Evaluation of a Proposal for Cyanide Extraction of Gold and Silver from Mine Waste at the Leadville Mill, Lake County, West-Central Colorado

Steven H. Emerman, Malach Consulting, 785 N 200 W, Spanish Fork, Utah 84660, USA, Email: SHEmerman@gmail.com, Tel: 1-801-921-1228

Report prepared at the request of Concerned Citizens for Lake County, submitted July 23, 2024

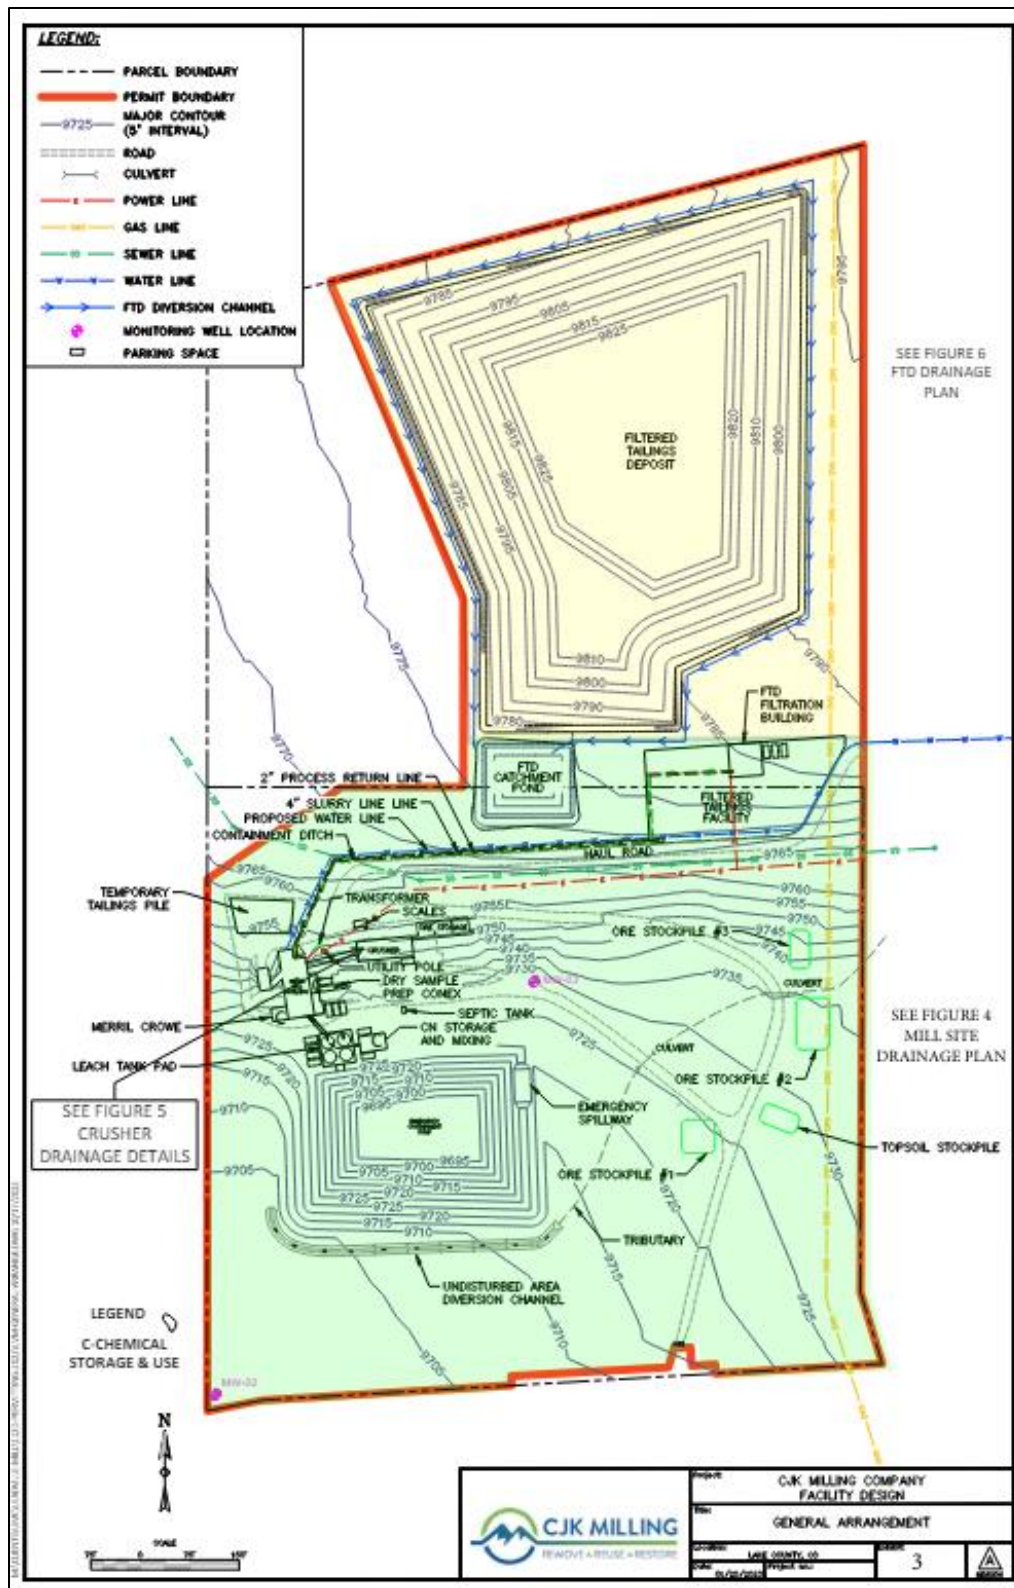
It is not possible even to establish the correct permit boundary or the correct perimeter of the filtered tailings deposit (FTD). Although the permit boundary shown in Fig. 19a (taken from the permit application) was used to construct the maps for this report, Fig. 23 (taken from the same permit application) shows a completely different size and shape for the permit boundary. In the same way, although the perimeter of the FTD shown in Fig. 19b (taken from the permit application) was used to construct the maps for this report, Fig. 17b (taken from the same permit application) shows a completely different size and shape for the perimeter of the FTD. The permit boundary and FTD perimeter shown in Fig. 17a appear similar to what is shown in Figs. 19a-b, but that does not adequately resolve the question as to which information in the permit application is the correct information.

Figure 23. The application by Union Milling Company (2024) is filled with contradictory information. For example, the permit boundary and perimeter of the filtered tailings deposit in the above figure are inconsistent with the same information in other figures (compare with Figs. 17a and 19a-b). The perimeter of the filtered tailings deposit is, however, consistent with Fig. 17b. Figure from Union Milling Company (2024).

- 1) The permit application has multiple versions of the permit boundary and the perimeter of the filtered tailings deposit (FTD) (compare Figs. 17a-b, 19a-b and 23). For example, some components of the stormwater management plan are based on one version of the FTD perimeter, while other components are based upon a different version of the FTD perimeter (compare Figs. 17a and 17b).
- 2) While the permit boundary covers 42.93 acres and the affected land covers 42.60 acres, less than 20 acres is accounted for in the stormwater management plan (see Fig. 18).

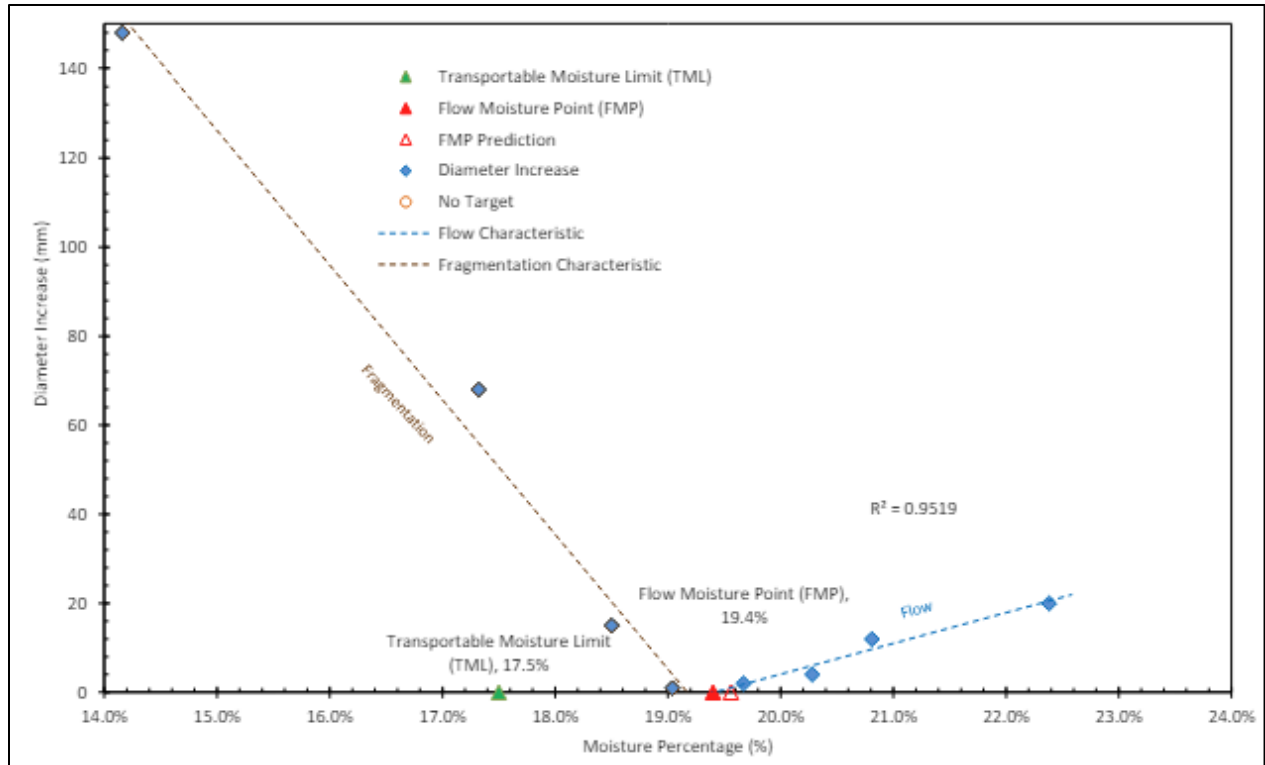
Figure 24b. For the tailings that would be produced at the Leadville Mill, Union Milling Company (2024) determined the flow moisture point to 19.4% and the transportable moisture limit to be 17.5%, where the percentages refer to the process water content. The flow moisture point is the water content above which the material exhibits fluid-like behavior (see Figs. 25a-b). The graph indicates that, for water contents greater than the flow moisture point, after disturbance (described only as “after 25 drops”), the filter cake increased in diameter due to flow. The pre-disturbance diameter was not stated. For water contents less than the flow moisture point, the filter cake fragmented (as opposed to flowed) after disturbance. Since Union Milling Company (2024) has stated the target water content for the filtered tailings deposit sometimes as the range 20-30% and sometimes as less than 25% (see Fig. 16), the filtered tailings deposit will be unstable because it will flow as it is constructed. Figure from Union Milling Company (2024).

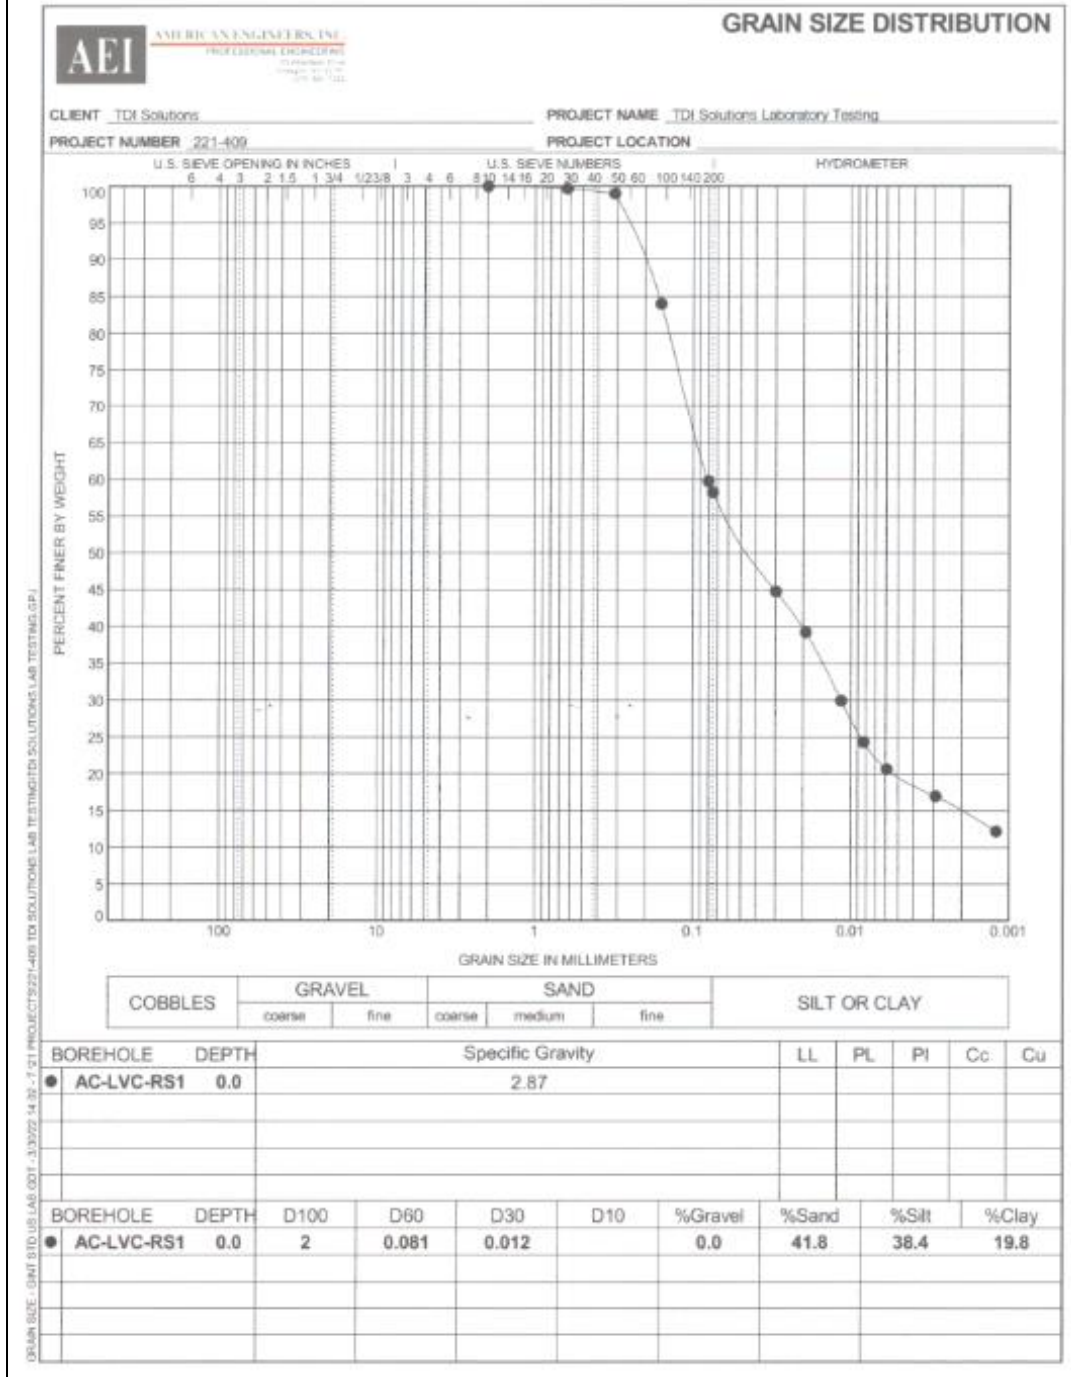
Figure 25b. For the tailings that would be produced at the Leadville Mill, Union Milling Company (2024) determined the flow moisture point to 19.4% and the transportable moisture limit to be 17.5%, where the percentages refer to the process water content. The flow moisture point is the water content above which the material exhibits fluid-like behavior. The above photo shows the filter cake before (left-hand side) and after (right-hand side) disturbance at a water content of 23.9%. The photo clearly indicates extreme flow behavior at a water content exceeding the flow moisture point. Since Union Milling Company (2024) has stated the target water content for the filtered tailings deposit sometimes as the range 20-30% and sometimes as less than 25% (see Fig. 16), the filtered tailings deposit will be unstable because it will flow as it is constructed. See photos of lower water contents (19.7%, 20.3%, 20.8%, 22.4%) in Fig. 25a. Photos from Union Milling Company (2024).

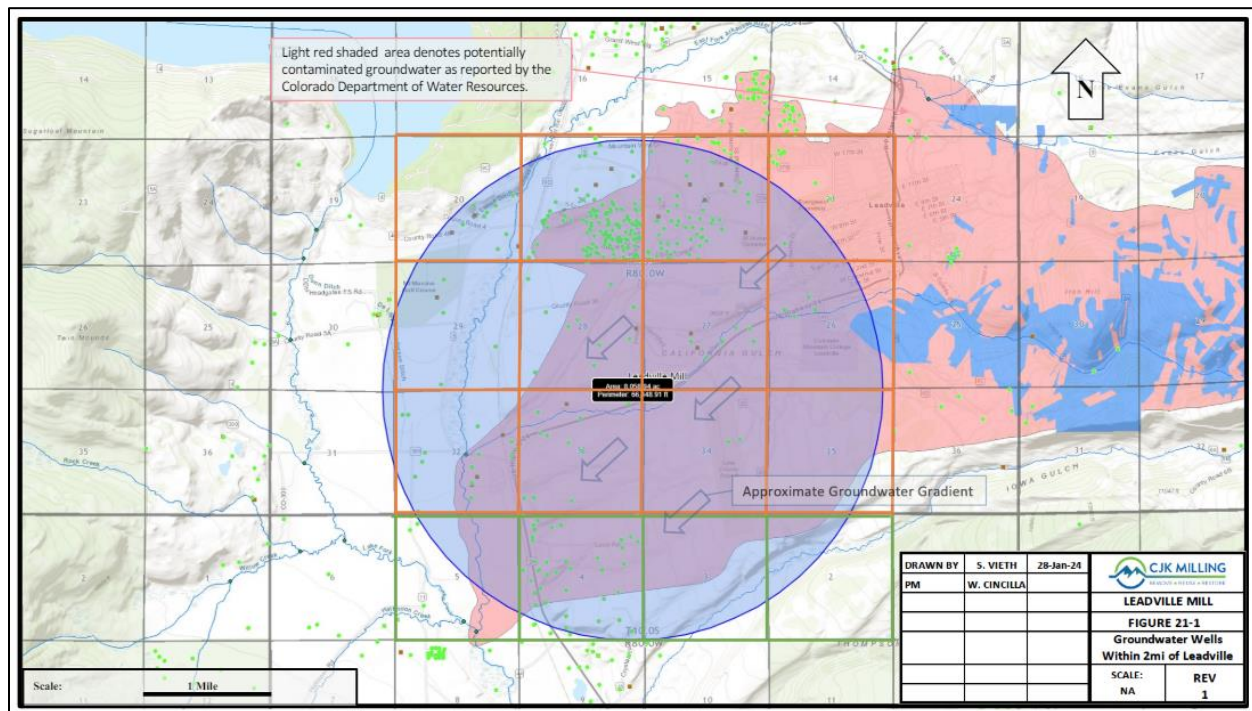
The only hydrogeological information in the permit application is a map that shows groundwater flowing to the southwest in the vicinity of the Leadville Mill (see Fig. 29). The permit application does not provide any justification for the assumed flow to the southwest, nor does the application state the depths or aquifers in which the assumed flow is occurring or recognize the possibility that groundwater might be flowing in different directions in different aquifers or that the groundwater might be dominated by vertical flow at some locations. The map includes a light red shaded area that “denotes potentially contaminated groundwater as reported by the Colorado Department of Water Resources” (Union Milling Company, 2024). The permit application does not provide any information regarding the potential plume of contaminated groundwater or any source for the information from the Colorado Department of Water Resources. Union Milling Company (2024) also does not provide any information regarding how it could distinguish between the flow of an existing plume of contamination and any future contamination from the proposed remining operation. The same concern was expressed in the “Groundwater and Surface Water Specific Adequacy Review” by Colorado DRMS (2024b). The preceding list continues:

8. “Please provide additional information regarding the light red shaded background in Figure 21-1 [Fig. 29 in this report] indicating potentially contaminated groundwater and

how it impacts groundwater quality results at the site and down gradient from the site. Additionally, how does this impacted groundwater affect the Applicant's ability to detect, or not, if there is a release of toxic material or designated chemicals at the site."

Figure 29. Union Milling Company (2024) claims that groundwater is flowing to the southwest in the vicinity of the Leadville Mill, but without providing any evidence. The possibility that the groundwater flow direction might be different in different aquifers was not considered. In addition, no evidence was provided for the existence of a plume of contaminated groundwater flowing to the southwest. Union Milling Company (2024) provided no information as to how it could distinguish between the flow of the existing plume of contamination and any future contamination from the proposed remining operation. See Fig. 30 for other possible directions for groundwater flow that would be consistent with the existing information. Figure from Union Milling Company (2024).
